CAP MEETING 11 August 2021  
DA 21009955 – 39 Emmett Road Crafers West

<b>DEVELOPMENT NO.:</b>	21009955
<b>APPLICANT:</b>	Ulrich Schade Mang Chun Alfred Teng
<b>ADDRESS:</b>	39 EMMETT RD CRAFTERS WEST SA 5152 <b>Title ref.:</b> CT 5545/209 <b>Plan Parcel:</b> F150979 AL24
<b>NATURE OF DEVELOPMENT:</b>	Variation to existing Development Approval 19/580/473 - Changes to retaining wall
<b>ZONING INFORMATION:</b>	<b>Zones:</b> <ul style="list-style-type: none"><li>• Hills Face</li></ul> <b>Overlays:</b> <ul style="list-style-type: none"><li>• Environment and Food Production Area</li><li>• Hazards (Bushfire - High Risk)</li><li>• Hazards (Flooding - Evidence Required)</li><li>• Native Vegetation</li><li>• Prescribed Wells Area</li><li>• Regulated and Significant Tree</li></ul>
<b>LODGEMENT DATE:</b>	25 May 2021
<b>RELEVANT AUTHORITY:</b>	Council Assessment Panel
<b>PLANNING &amp; DESIGN CODE VERSION:</b>	2021.6
<b>CATEGORY OF DEVELOPMENT:</b>	Code Assessed - Performance Assessed

Variation to existing Development Approval 19/580/473 - Changes to retaining wall

IMAGE OF INTERNDED STYLE OF  
ROCK RETAINING WALLS  
(TO ENGINEERS DESIGN)

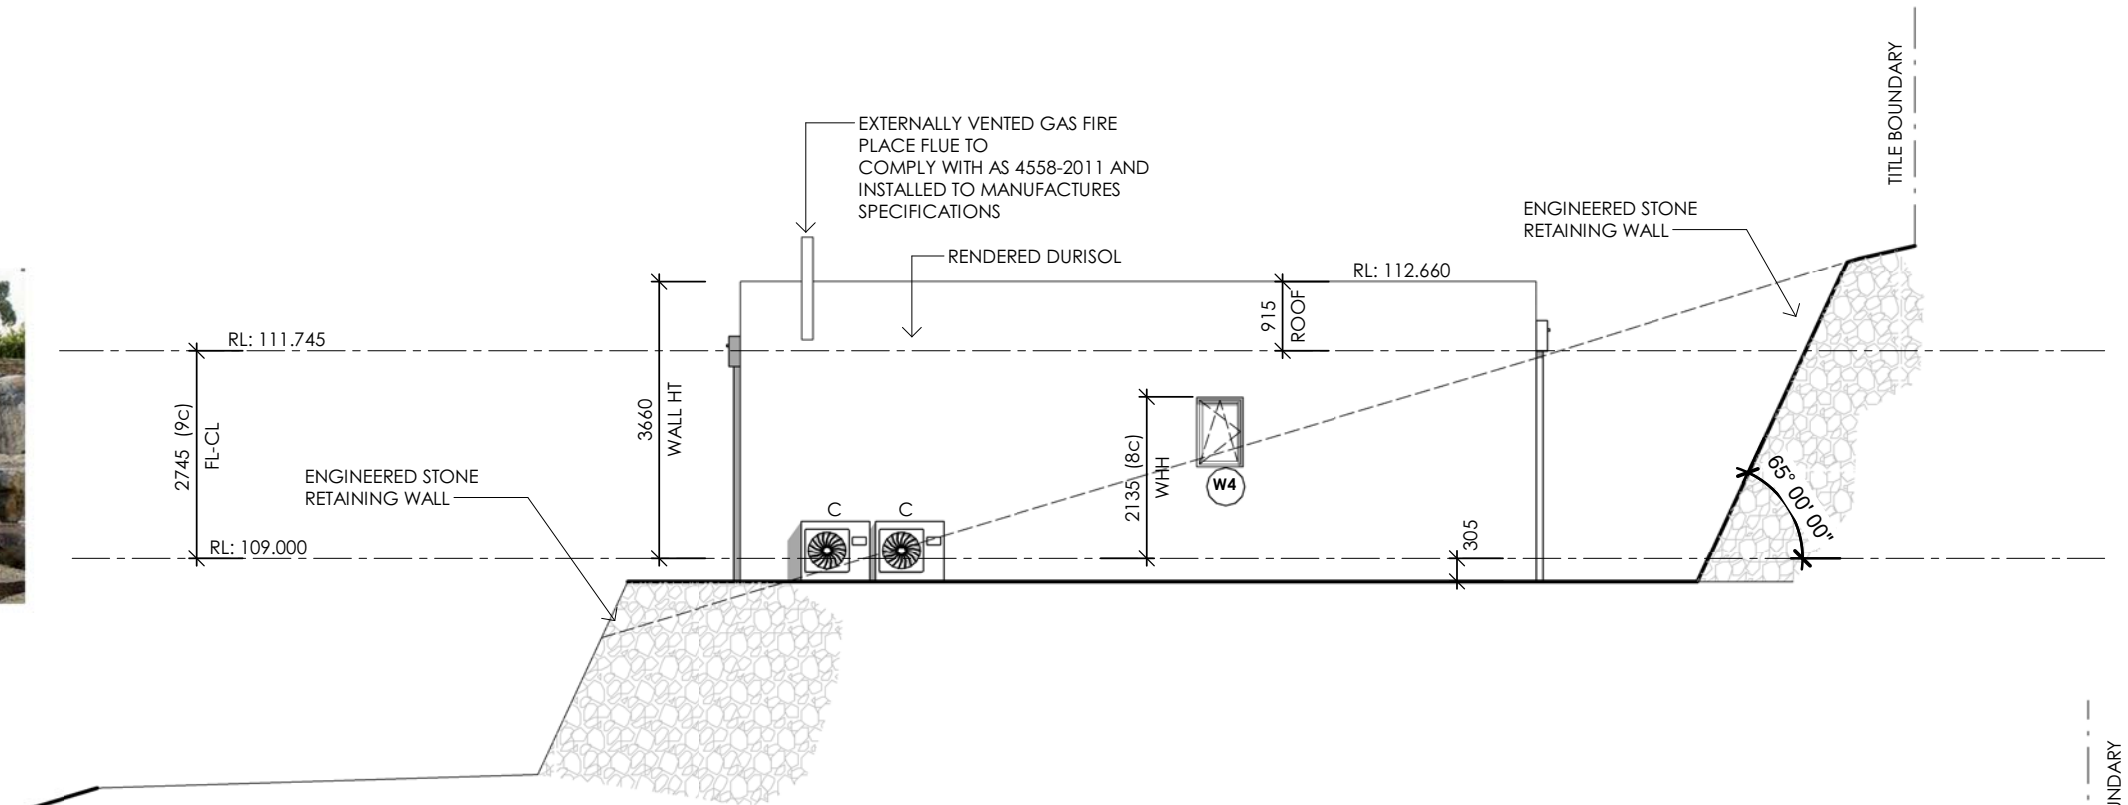
- Rock retaining wall on Harvan design sheet 5 of 10 is a misrepresentation of style of retaining wall being proposed.
- Retaining walls not accurately represented on elevation or section drawings.

Image 1: Evolution of the wall

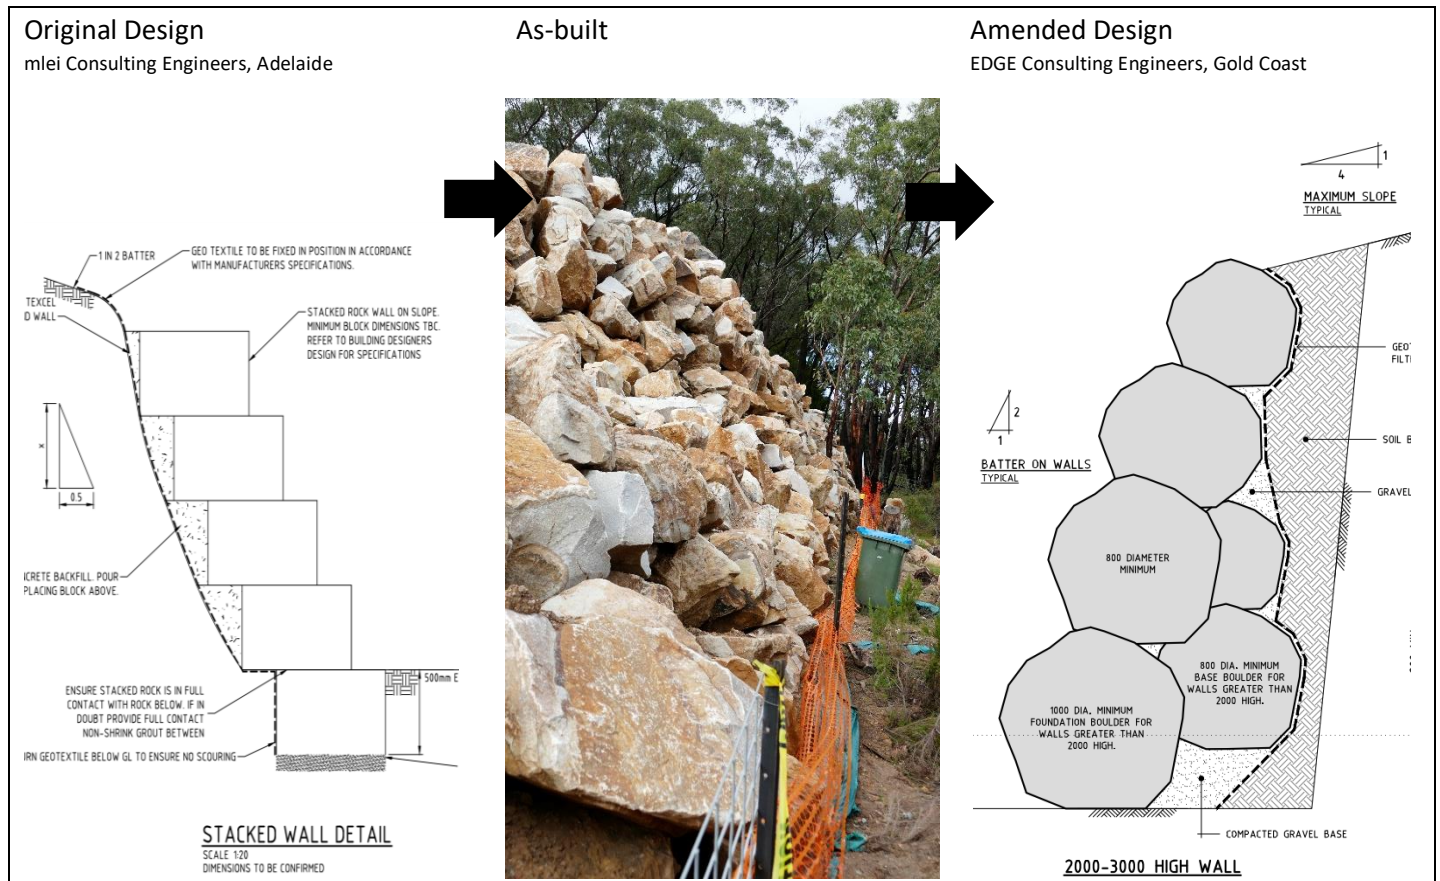
The original plans approved in 2020 specified a stacked stone retaining wall constructed from regular shaped blocks, either in close contact with each other or grouted, and backfilled with concrete. During development, the developer instead elected to build a wall from loose irregular shaped rocks at a very steep batter angle of 1:2. The developer now seeks retrospective approval for an alternative design entirely different to the approved plans.

Image 6: Amended Plan issues

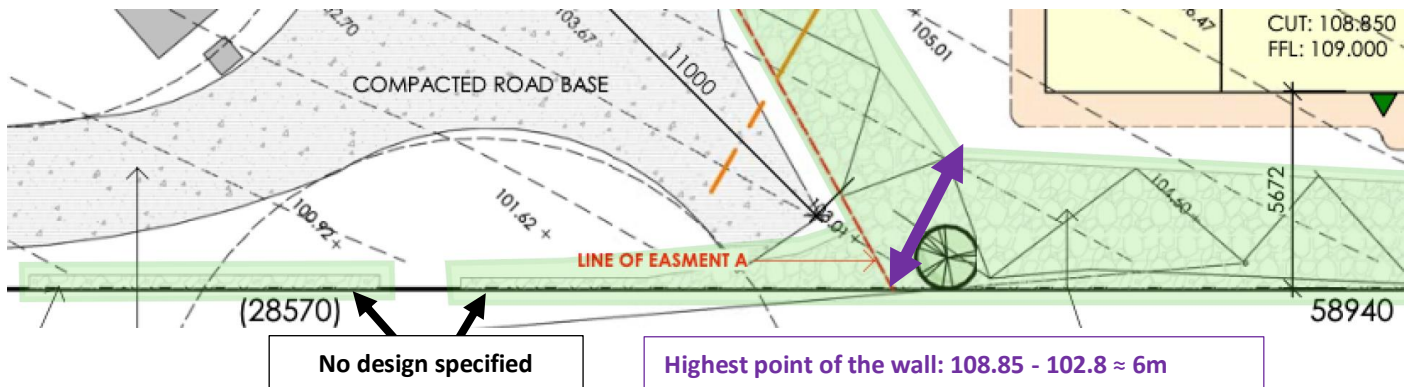
The drawings supplied by the replacement engineer "EDGE Consulting" (Gold Coast, Queensland) provide for rock walls up to 3000mm high. The application is generally vague on the maximum wall height required. At the highest point of the wall where the 39/43 boundary intersects the Line of Easement A, I make the original elevation to be 102.8m and the CUT is 108.85, a difference of 6m (see below). The ROCK RETAINING WALL drawing however only provides for a maximum height of 3000mm which is clearly far short of 6m. The red coloured NOTE regarding 6m high walls refers to INTERNAL corners. The highest point on the wall is an EXTERNAL corner.

This gives me great reason for concern because of what has happened in the past as the 55° batter cannot be supported naturally.
